**Multiple Sewershed Package 17A
Solicitation Number: CO-00413
Job No.: 20-4507**

**ADDENDUM 1
November 18, 2021**

MULTIPLE SEWERSHED PACKAGE 17A
CIPP REHABILITATION
SAWS JOB NO 20-4507

Dwg. No. **BP-124**

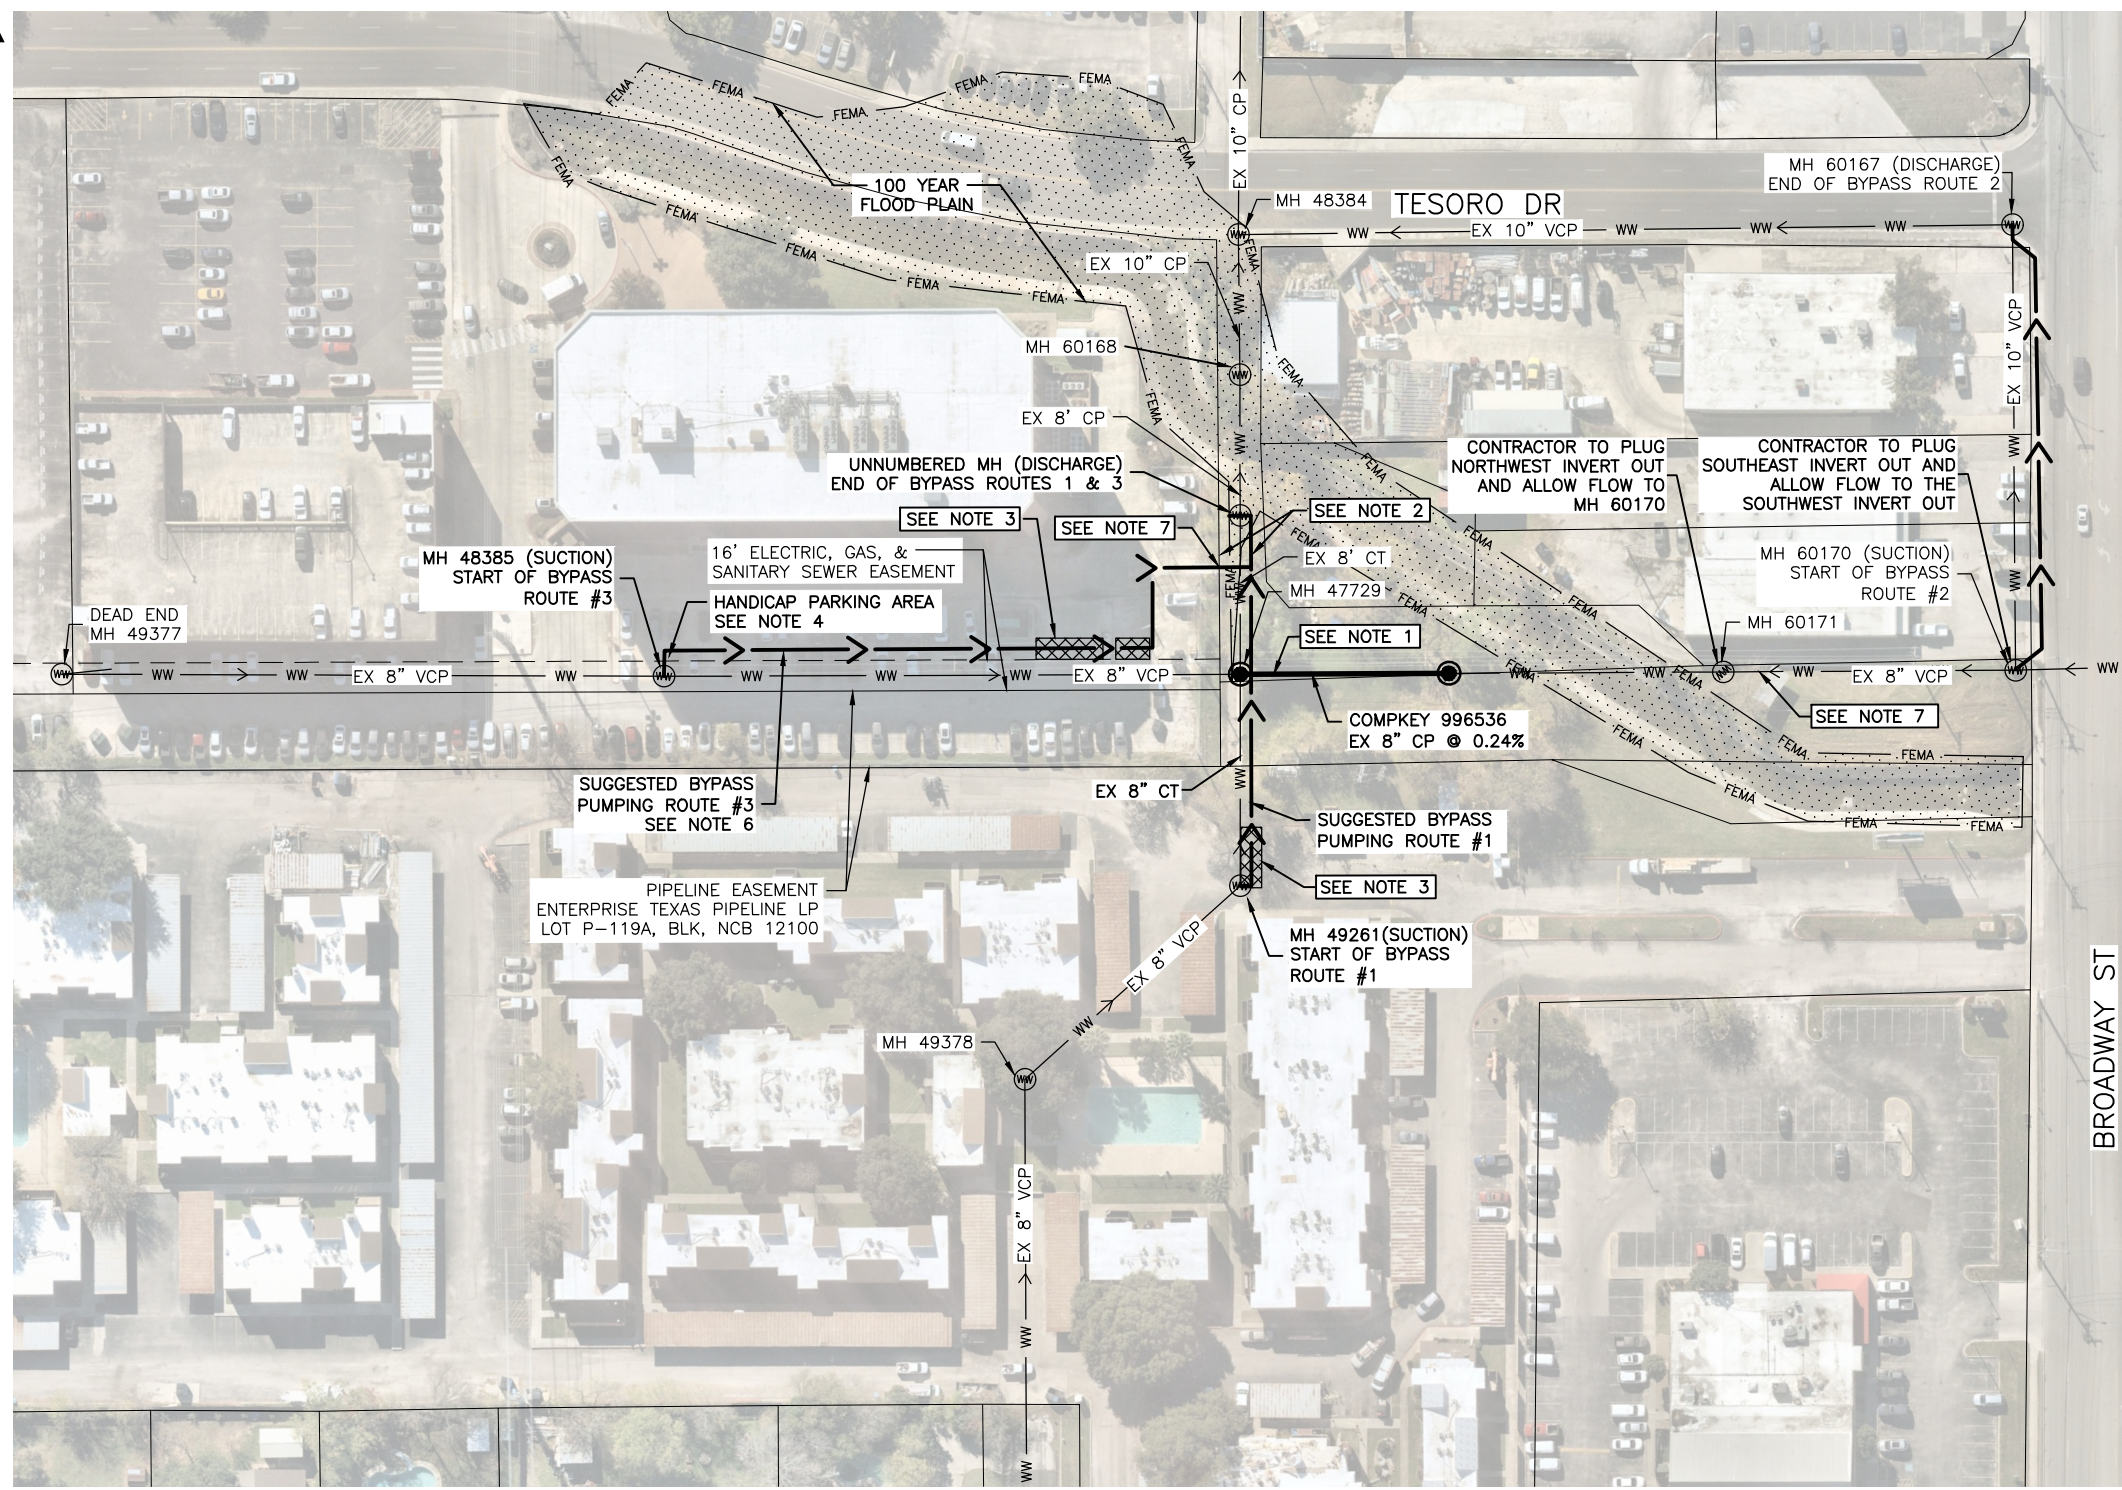
1. REMOVE Sheet BP-124 dated 10/26/2021 in its entirety and REPLACE with the attached version dated 11/2/2021. The following items were updated:
 - a. The proposed bypass pumping route has been altered and specifying notes have been added reflecting the route agreed to by property owner.

- BYPASS PUMPING NOTES:**
1. THE CONTRACTOR SHALL COORDINATE WITH PROPERTY OWNERS FOR BYPASS PUMPING PLAN. CONTRACTOR SHALL PUMP AND HAUL AS NEEDED TO ELIMINATE ANY IMPACTS TO RESIDENTS.

2. CONTRACTOR SHALL BE RESPONSIBLE FOR SECURING THE BYPASS PUMPING LINES USING A METHOD OR METHODS THAT DISCOURAGE MOVEMENT, FLOATATION OR RUPTURING OF THE LINE IF FLOWS ARE ENCOUNTERED IN THE EXISTING STORM SEWER SYSTEM.

3. PORTIONS OF BYPASSING PIPING WILL REQUIRE ROAD RAMPS OR NEED TO BE BURIED IN ORDER TO MAINTAIN TRAFFIC THROUGH INTERSECTIONS AND ACCESS TO DRIVEWAYS. CONTRACTOR SHALL INDICATE LOCATION OF ROAD RAMPS AND DURATION OF PLACEMENT AS PART OF BYPASS PUMPING AND PHASING PLAN SUBMITTAL.

4. HANDICAP PARKING SPACES TO BE CLOSED DURING CONSTRUCTION. CONTRACTOR SHALL COORDINATE WITH NORTH EAST ISD TO TEMPORARILY DESIGNATE NEW HANDICAP PARKING SPACES TO REPLACE THE ONES OBSTRUCTED BY BYPASS OPERATIONS DURING CONSTRUCTION.

5. CONTRACTOR SHALL COORDINATE WITH SAWS TO ENSURE CONSTRUCTION ACTIVITIES DO NOT OVERLAP WITH SAWS JOB NO. 21-5501 MULTIPLE SEWERSHED PACKAGE 17B.
 6. BYPASS ROUTE #3 SHALL TRAVERSE ALONG THE PARKING CURB STOPS AND PARKING SPACES SHALL REMAIN ACCESSIBLE.

7. BYPASS PIPING TO CROSS UNDER CHAINLINK FENCE AT CONCRETE FLUME.
